Architectural Review
and Historic Preservation Board
Special Memo

File: AR 19-15

RE: AR 19-15 (Sloop Medical Building)
Jan Court at Forest Avenue -- APN 002-210-066 et al.

C3.1

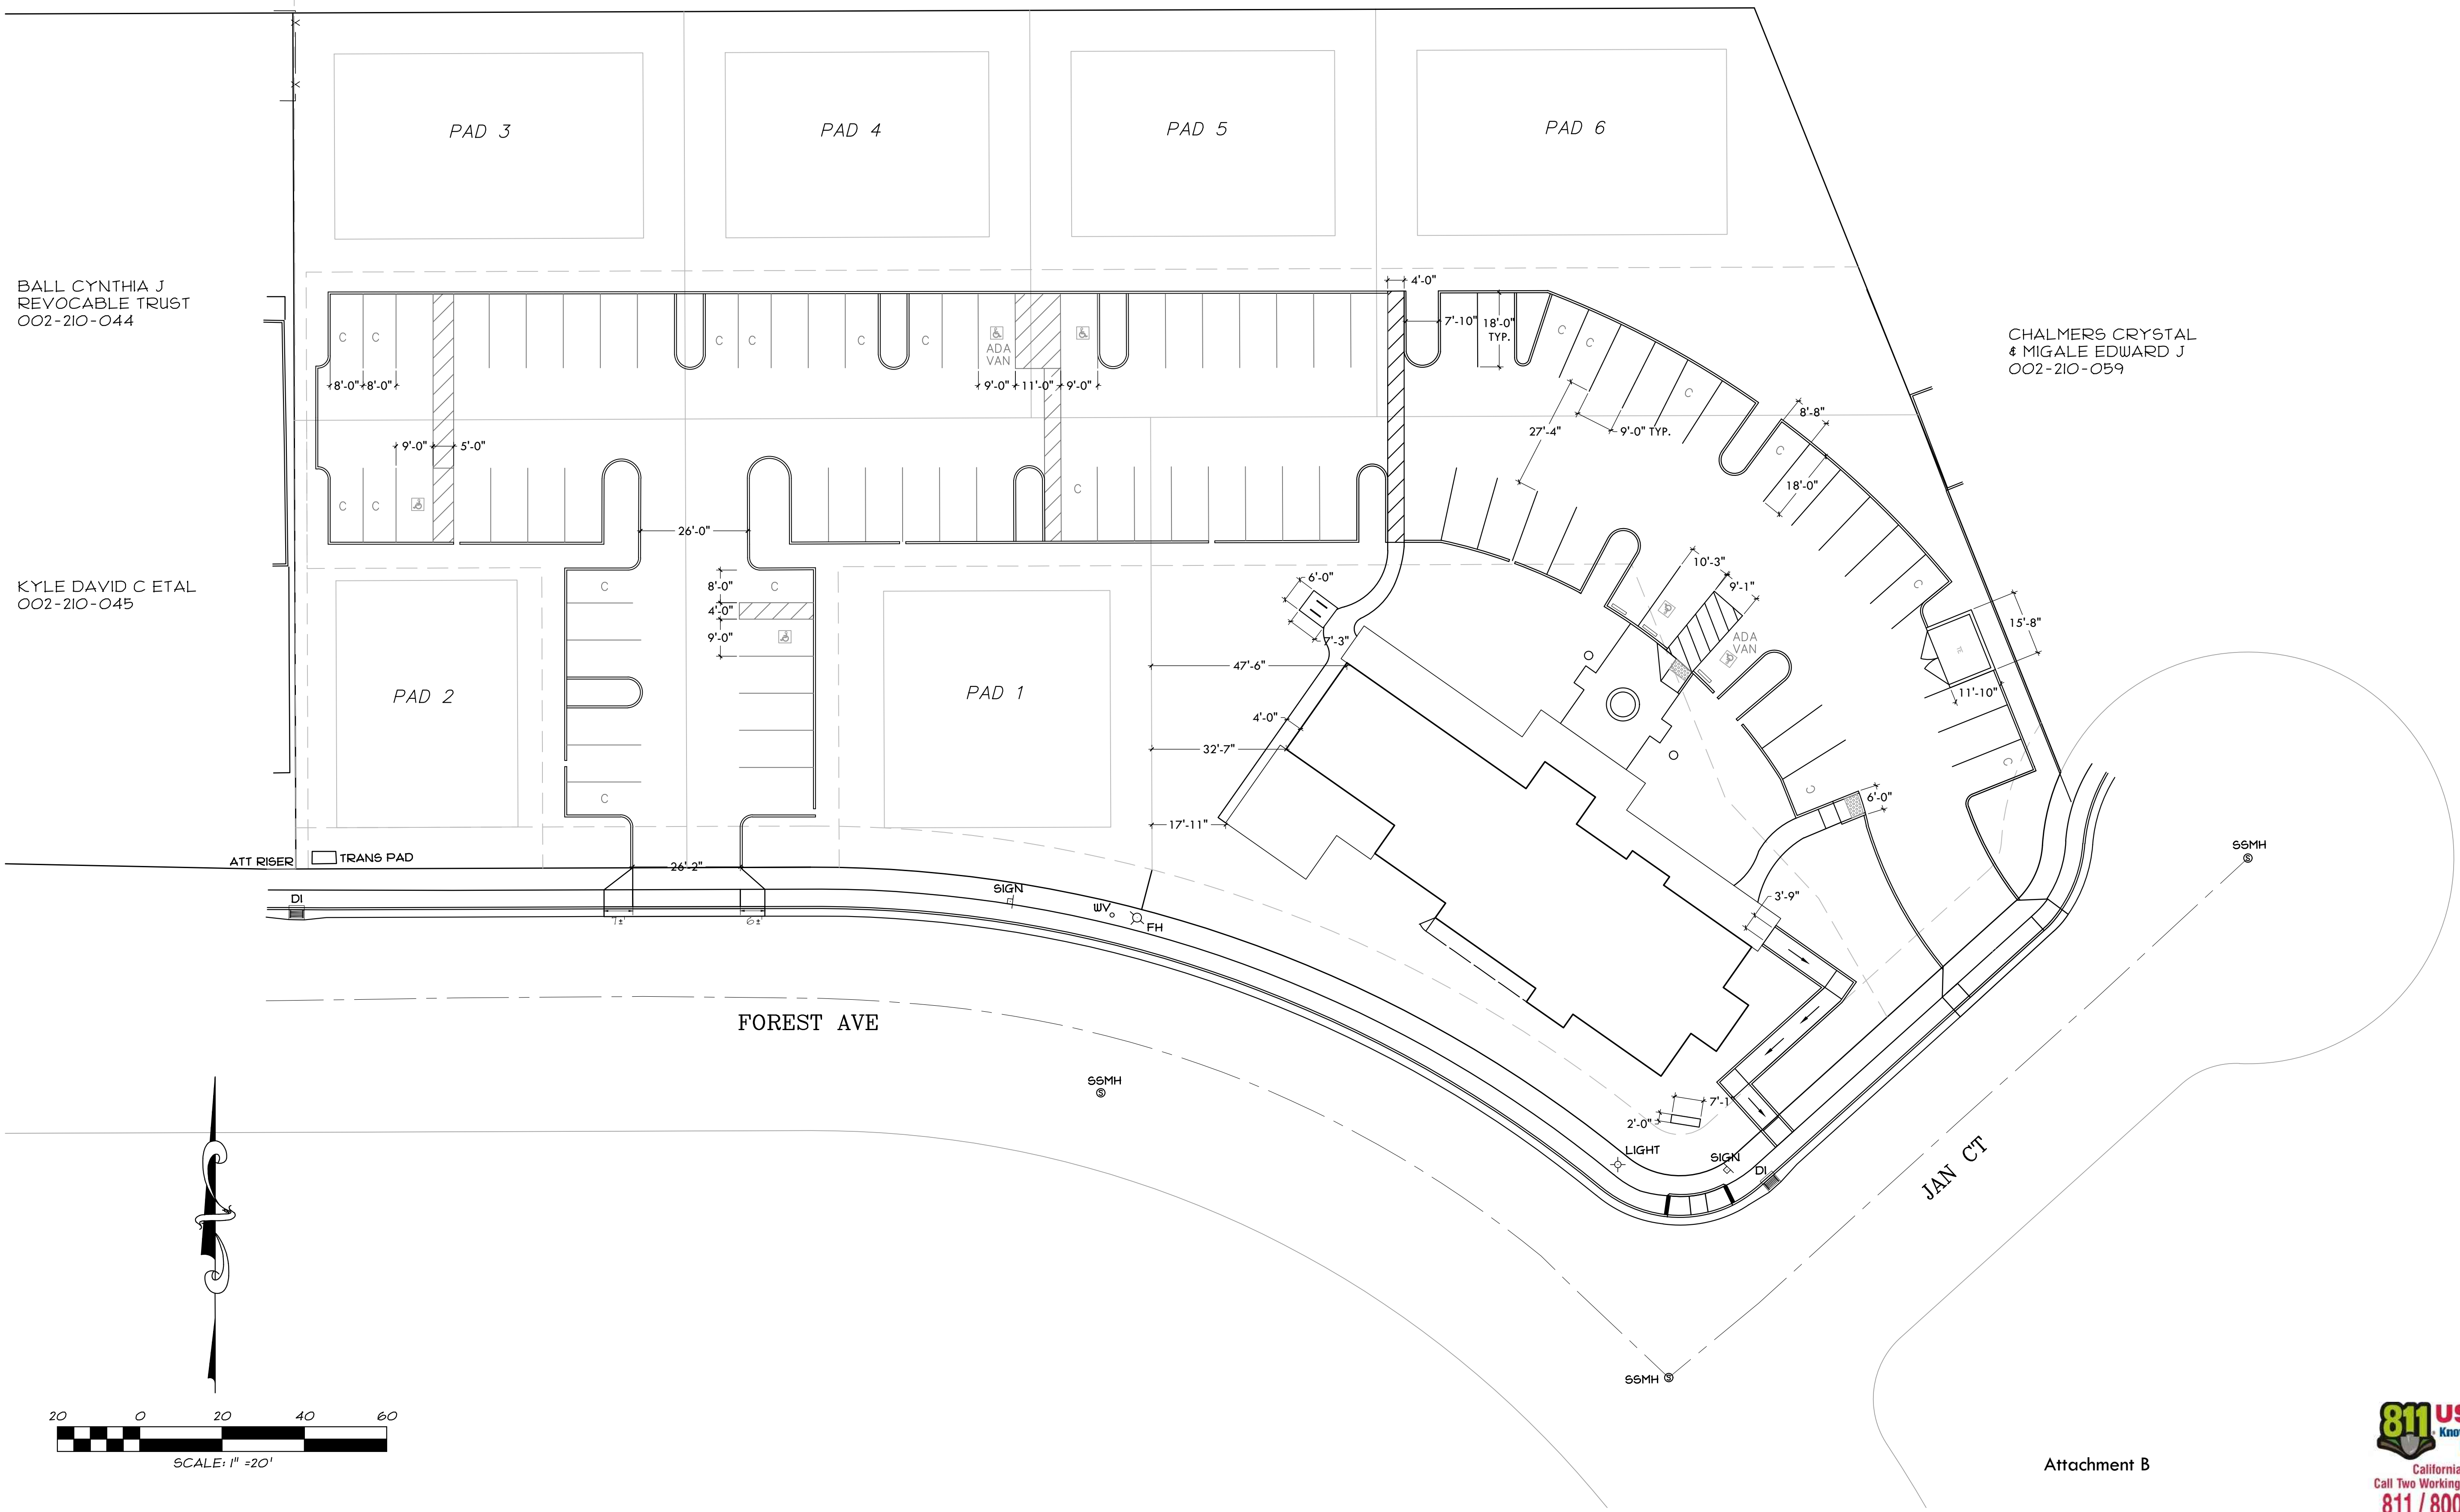
The proposed building would be set back from the intersection with landscaped areas in front and its parking area behind (see **Attachment B**, Site Plan). Additional new parking areas would extend through the site to the west. Twenty-three parking spaces are required for the new use, and 20 are provided wholly on the instant parcel, with five more partially present. 61 more would serve future buildings in the complex. With approximately 20,000 square feet of additional office space remaining, ultimate build out of the complex will likely be slightly overparked. Four bike parking spaces are provided in uncovered racks.

To achieve better consistency with Design Guidelines, Condition #6 has been added to require a structural cover over the bicycle parking area, and Condition #5 would require landscaping of the entire parking lot, not just the portion nearest the new structure. Because of consistency with the surrounding auto-oriented neighborhood context, it is somewhat justified for the site design to be auto-oriented. With conditions to improve DG consistency, staff supports approval of the project.

6. Applicant shall provide a structural cover over the bicycle parking area or relocate the bicycle parking to a covered location within 20 feet of the front building entrance.

REAR ELEVATION

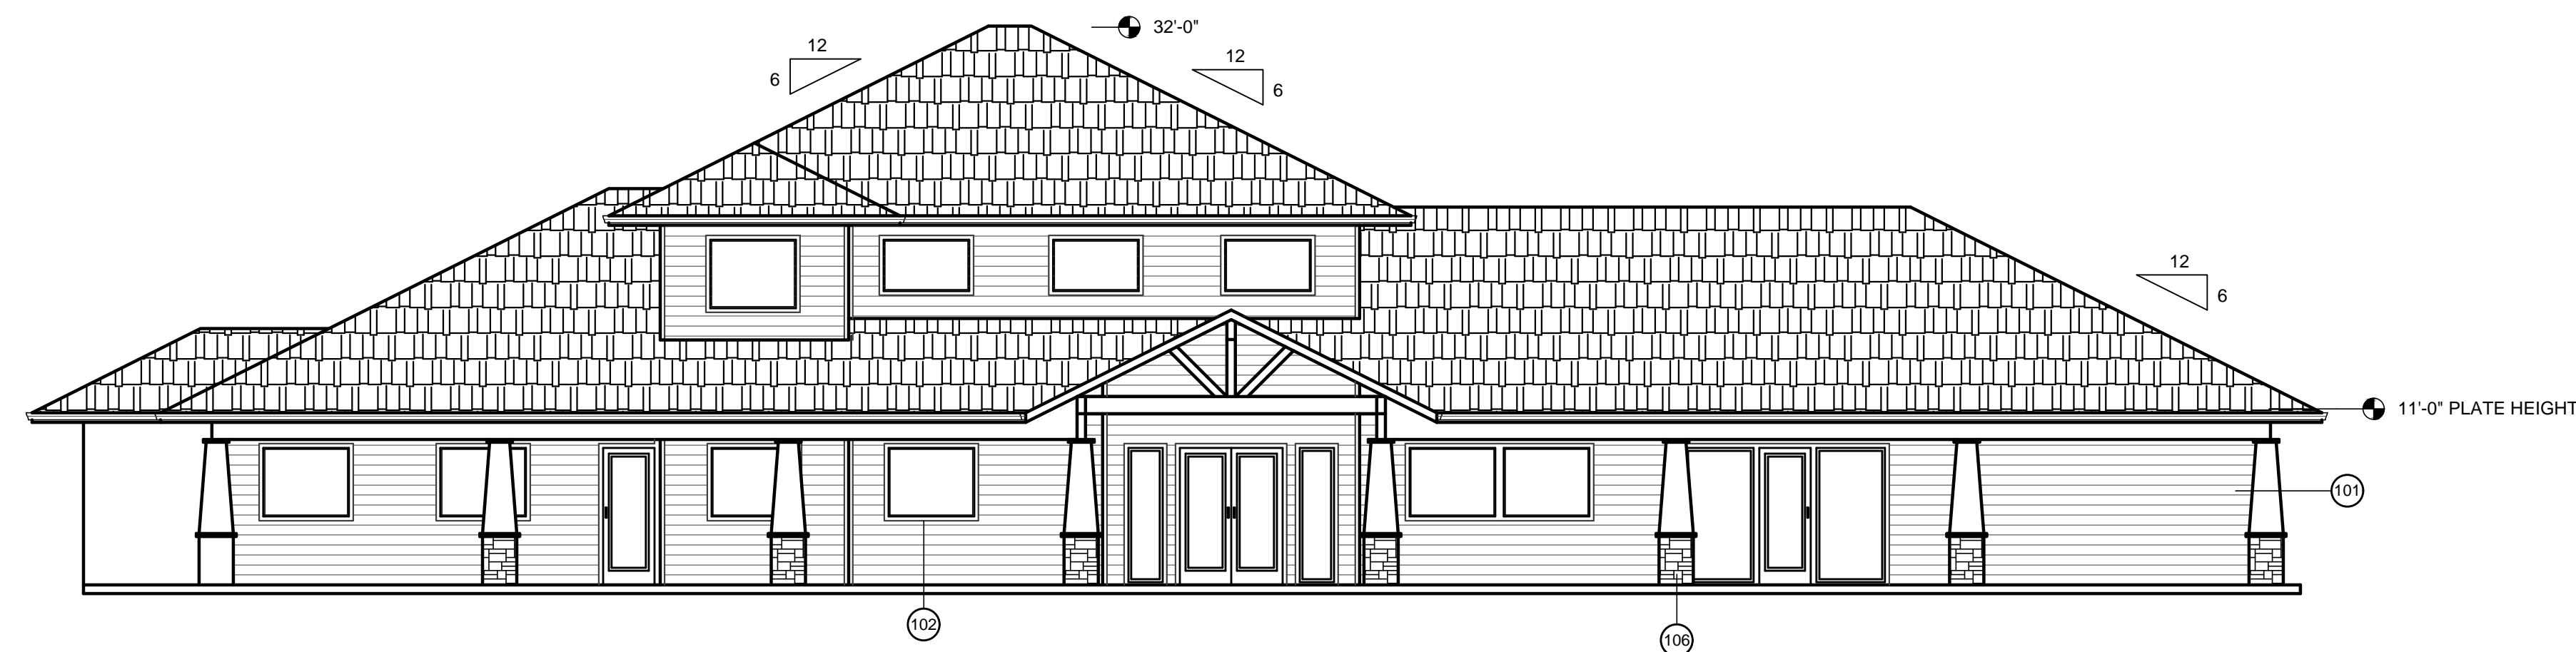
10. *Applicant shall, along the rear elevation, provide decorative elements that create a human scale on the rear of the structure.*
11. *Applicant shall paint a mural along the equipment screening on the rear elevation.*

Sheet: L-4
 Of: FOUR Sheets

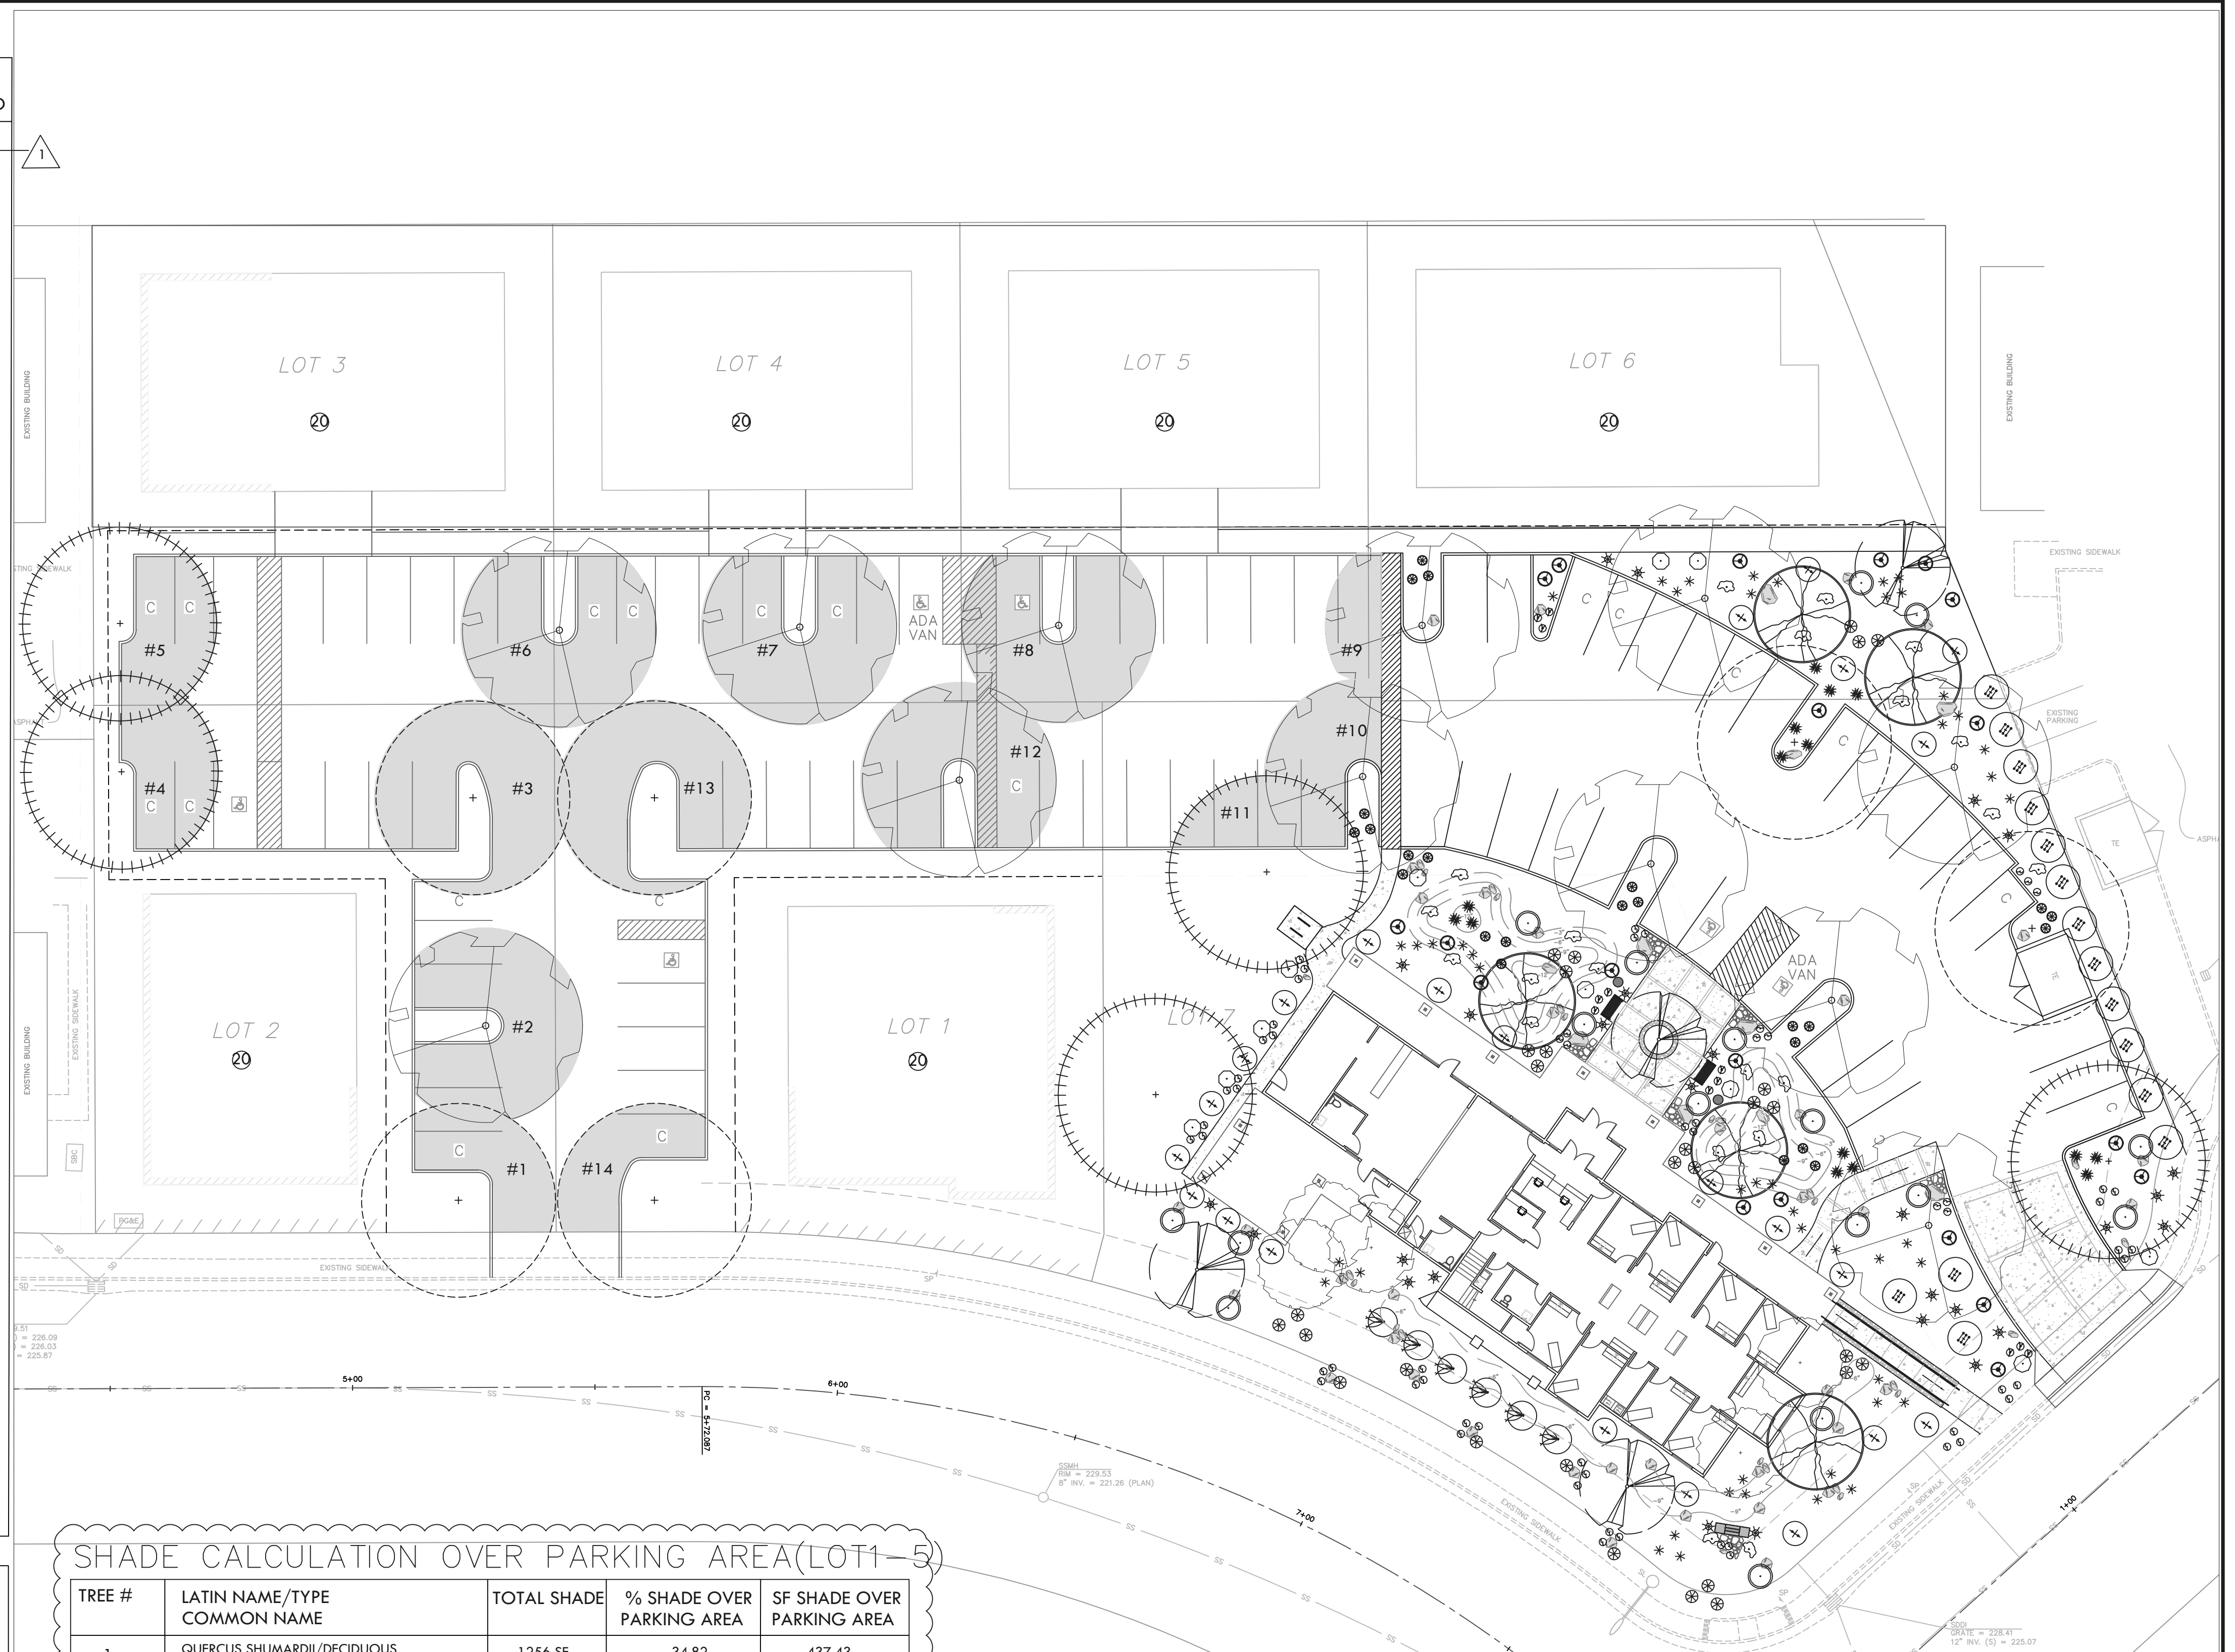
trees would be planted as well. Condition #5 has been added to require landscaping of the entire parking lot concurrent with its construction, so that parking lot shade and other landscaping requirements are met. A new trash enclosure would be located northeast of the building. The enclosure would be CMU block covered with a metal shed roof. Condenser units would be ground mounted on the side of the building facing Forest Avenue, screened by a wall appropriate for the commercial context.

The proposed landscaping will provide visual relief around the new parking area, and the substantial variety of new trees will be an important contributor to the proposed development. The variety of trees selected will provide an attractive environment with water use patterns that meet the city's requirements. Requiring the landscaping of the entire parking lot now will help to ensure that the property is visually appealing even if other parcels are not developed immediately.

5. Prior to issuance of a Certificate of Occupancy the applicant shall install landscaping for the subject parcel (APN 002-210-066), and throughout all parts of the parking area constructed concurrently as shown on the landscape plan. These landscape improvements shall be shown on the building plans and shall comply with City of Chico Municipal Code standards, including the provision of irrigation. Such landscaping shall include all tree cover required for the parking area's shade.
